Contract Title: Central Kowloon Route – Kai Tak West

Proactive Environmental Protection Proforma under Section 14.3 of the EM&A Manual

Ref: 202101

Proactive Environmental Protection Proforma for Revised Construction Sequence of Underwater Tunnel Construction

**Construction Sequence of 2-stage reclamation in CKR EIA
Report**

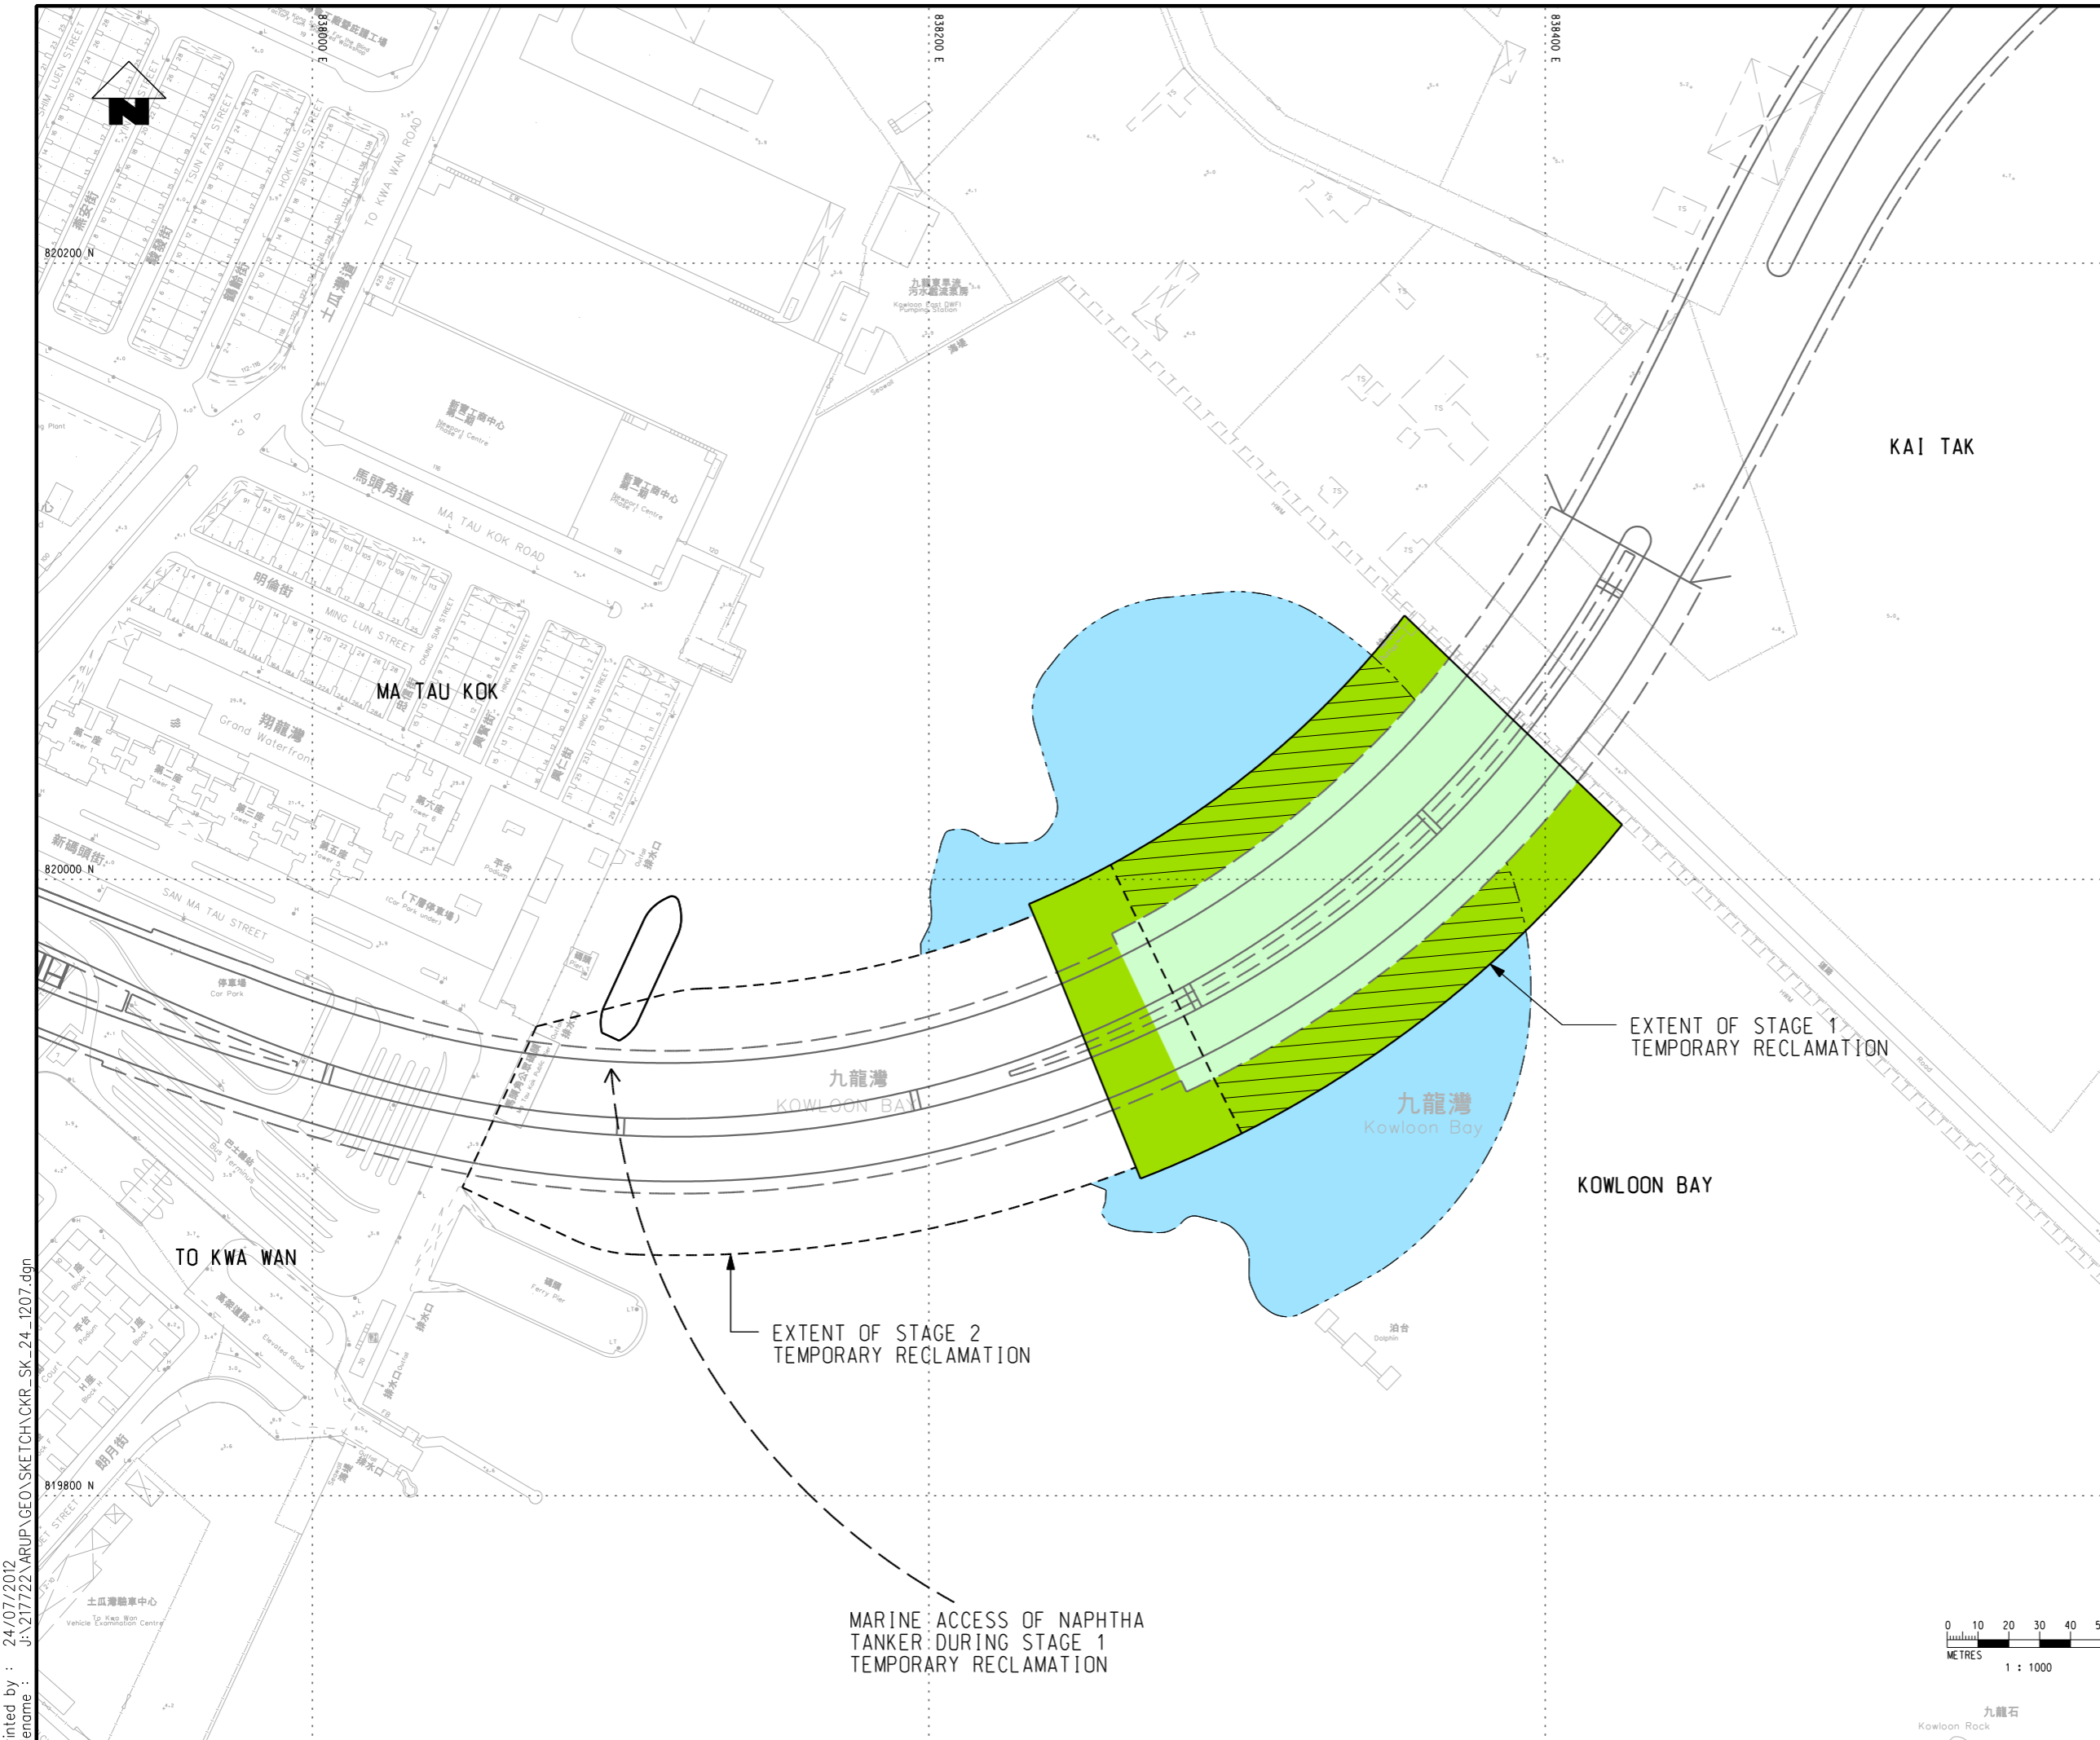
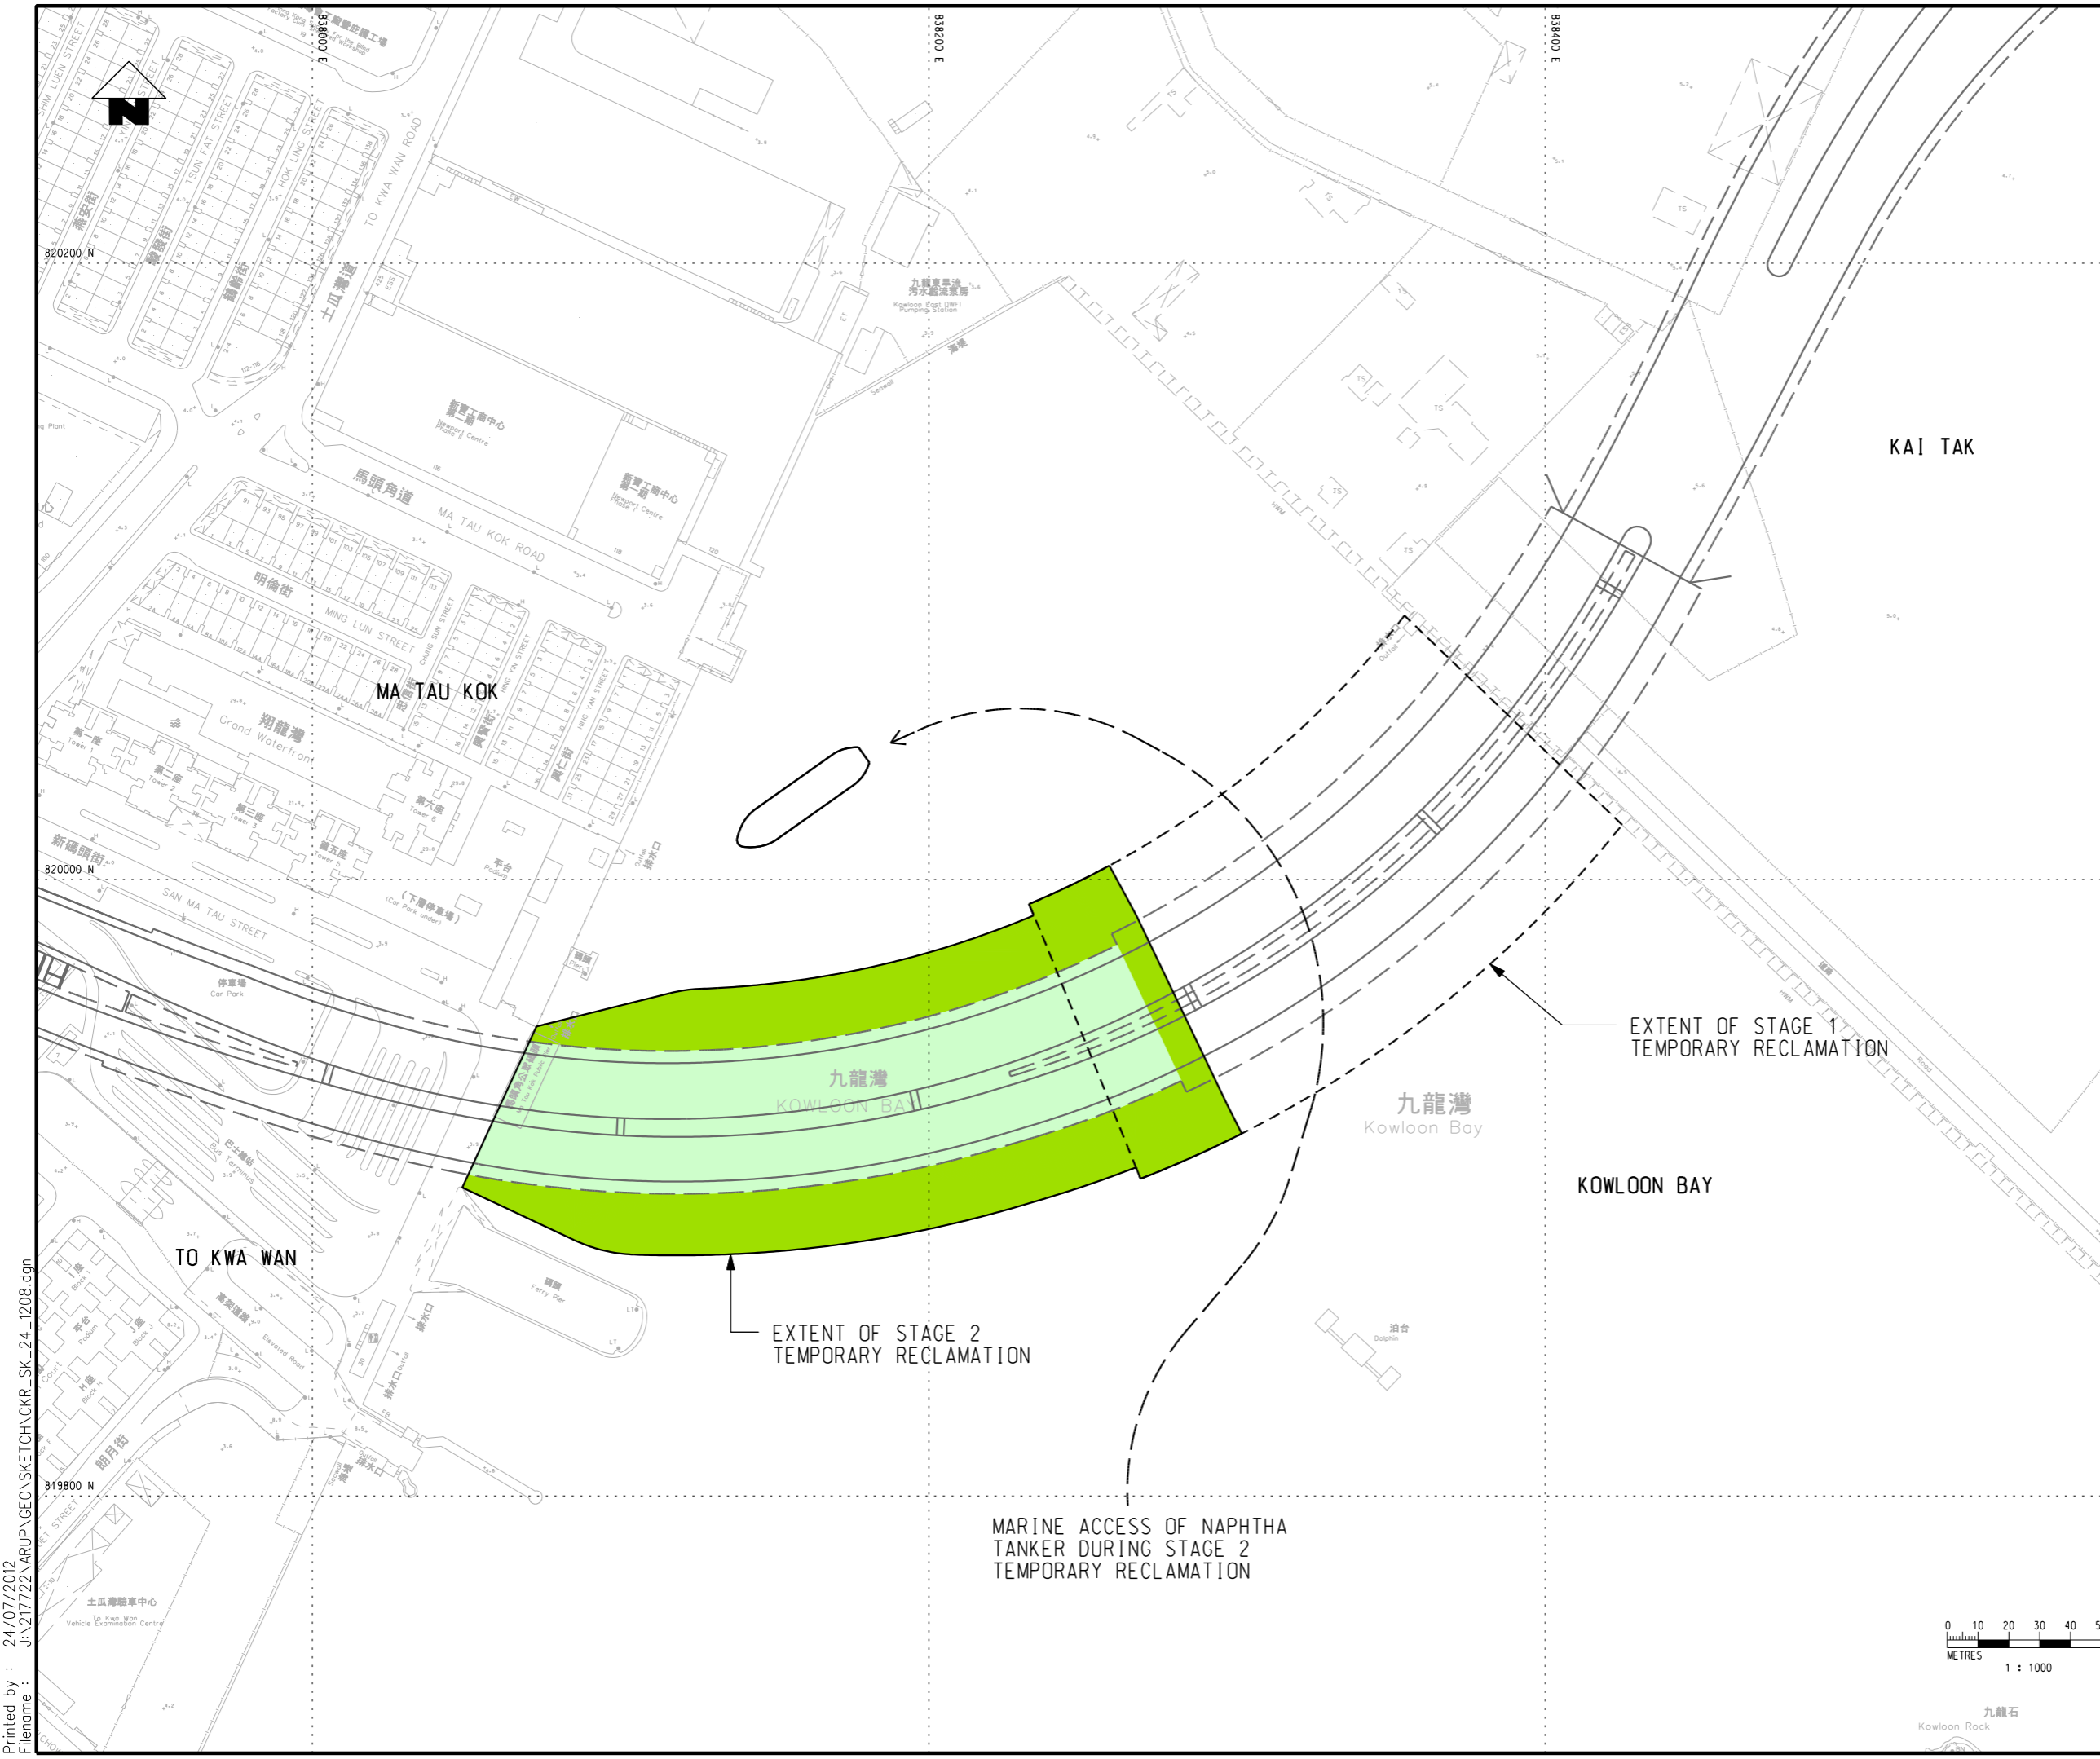
According to the latest development on the marine works, dredging of navigation channel as shown in **Annex A** is not necessary at this stage for marine access of Naphtha Tanker from TownGas, GCL proposes to revise the construction sequence for the Stage 1 and Stage 2 reclamation works as shown in **Annex B**.

**Proposed Construction Sequence for Underwater Tunnel
Stage 1 and Stage 2 Interface**

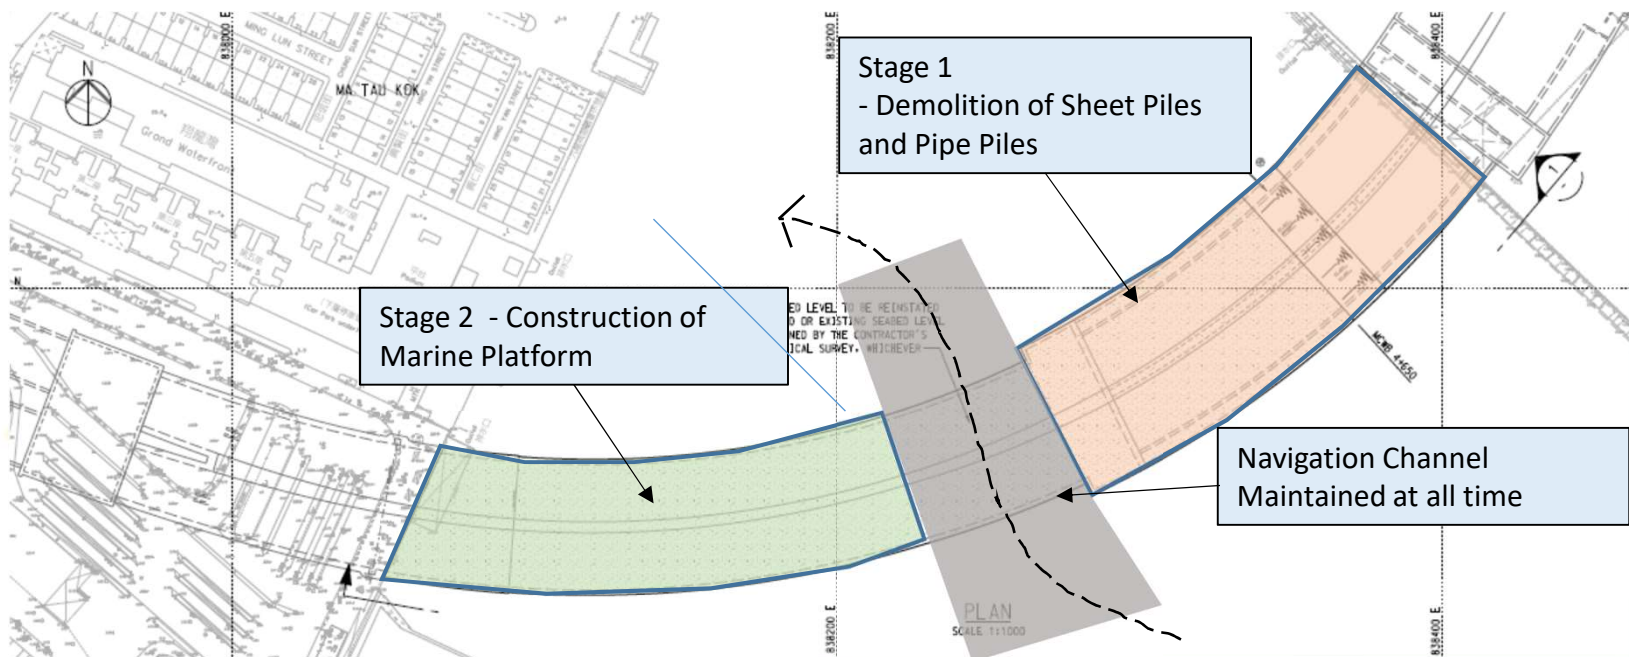
In the proposed scheme, the revised construction sequence of marine works are summarized as below:

- No open dredging is required
- Concurrent for Stage 1 sheet piles and pipe piles demolition and Stage 2 marine platform construction
- Maintain necessary navigation channel at all time
